SECTION 9

COOLING FAN AND PULLEY REPLACEMENT MODIFICATION OF THE C611505-0101 ALTERNATOR

Figure 9A-1. Alternator Fan and Pulley Replacement

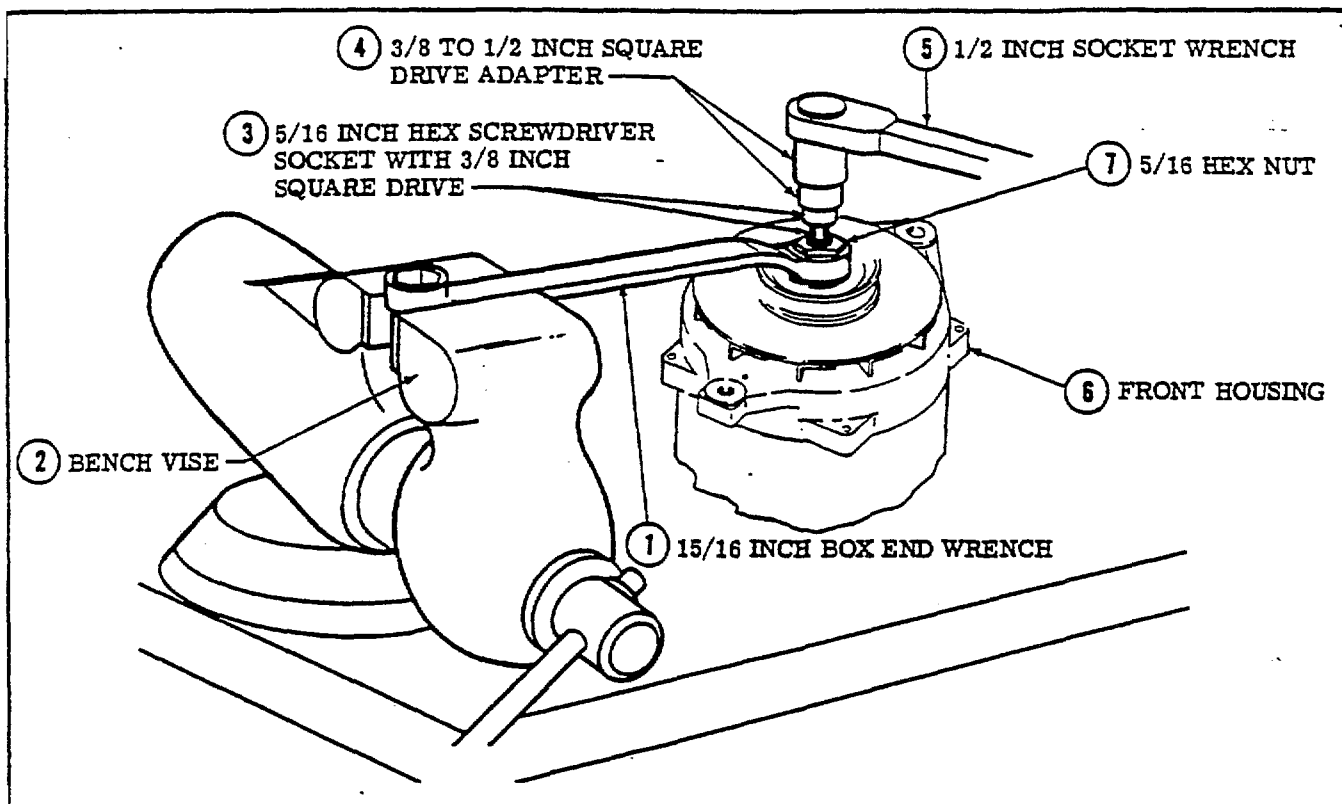
2. (Refer to Figure 9A-1) Place a 15/16 inch box end wrench (1) in a bench vise (2) and on the alternator shafts hex nut (3).
3. Using a 5/16 inch hex screwdriver socket with a 3/8 inch square drive (3), a 3/8 inch to 1/2 inch square drive adapter (4) and a 1/2 inch socket wrench (5), separate fan and pulley from the front housing (6) and shaft by removing hex nut (7). Retain lockwasher and hex nut (7).

6. (Refer to Figure 9A-1) Reinstall the 15/16 inch box end wrench (1) in a bench vise (2) and on the alternator shafts hex nut (7).
7. Using the 5/16 inch hex screwdriver socket with a 3/8 inch square drive (3), a 3/8 inch to 1/2 inch square drive adapter (4) and a 1/4 inch socket torque wrench, rotate shaft in a counterclockwise direction to a torque of 60 to 100 lb-ft torque. Be sure that the hex driver is fully seated into the hex hole in the shaft.

Figure 9A-2. Alternator Fan and Pulley Assembly Installation

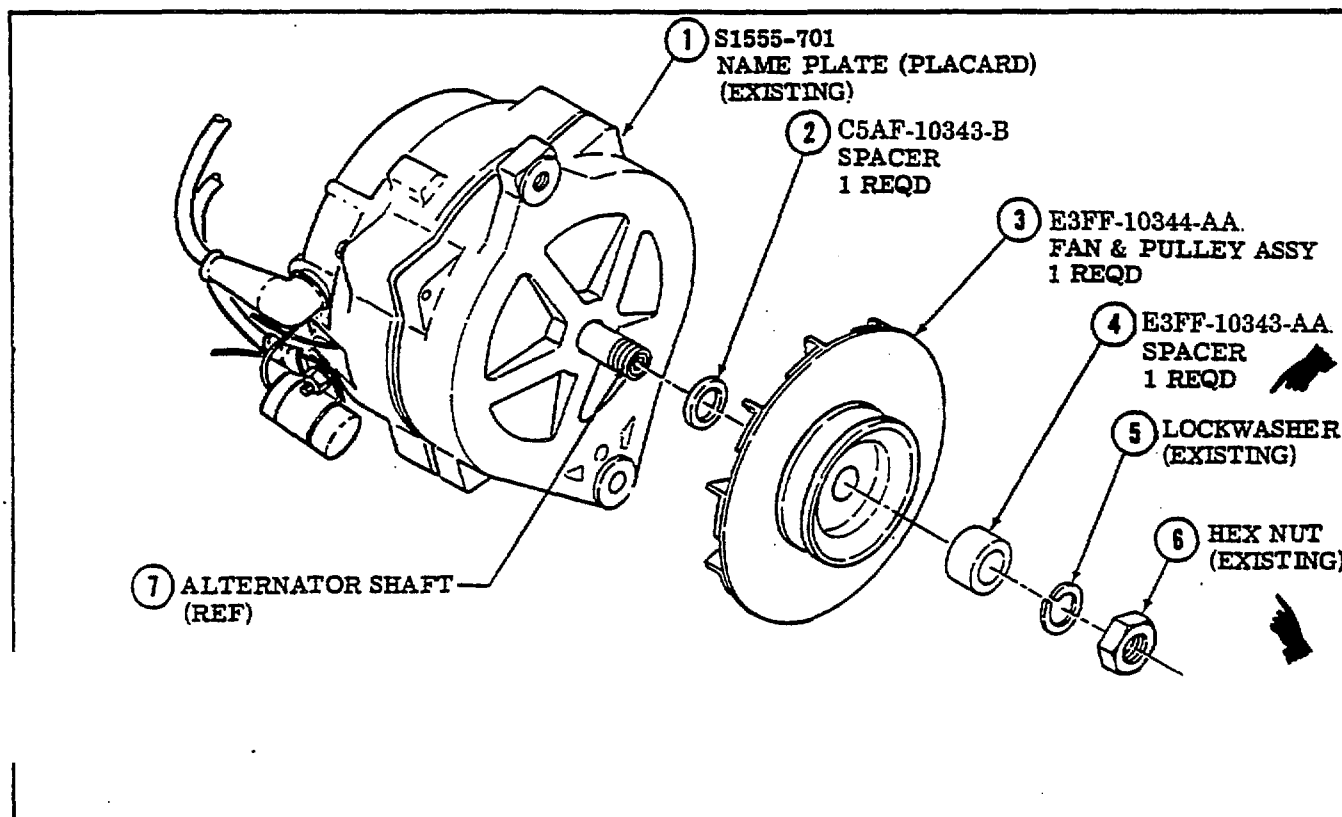
4. Discard existing fan spacer, fan and pulley. Retain lockwasher and hex nut.
5. (Refer to Figure 9A-2) Install the C5AF-10343-B spacer, E3FF-10344-AA fan and pulley assembly and E3FF-10343-AA pulley spacer using lockwasher and hex nut retained in Step 3.

8. (Refer to Figure 9A-2) Locate the existing name plate, item (1) and add the suffix letter "A" to the existing part number so it reads "C611505-0101A".
